Survey Found Raw Water Intake Valve Operational Deficiency

In conducting a survey, of a 1995 30' production express fisherman (built in USA), powered by twin 6 cylinder diesel engines installed new in 2009, a raw water intake valve with a restricted operation situation was encountered.

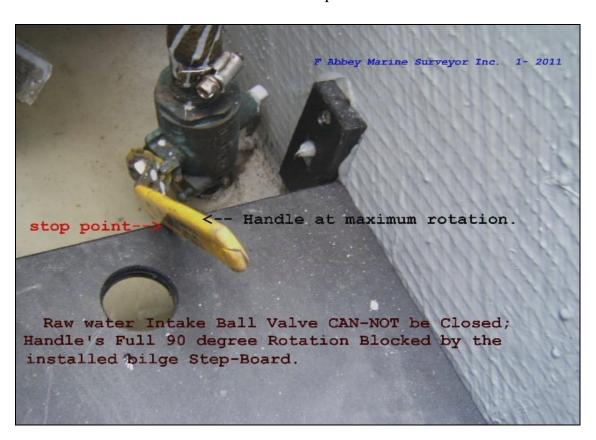
The photograph shows how full operation to close the Raw Water Intake Valve is blocked by the recently installed "bilge step board": The step board needs a cut-out so that the valve handle can be rotated 90° and be closed. Additional issues are: A) single clamped hose (the barb was too short for double clamping). B) bronze valve & through-hull are not bonded. C) the installed valve is in-line type and not the more preferred type flanged type sea valve.
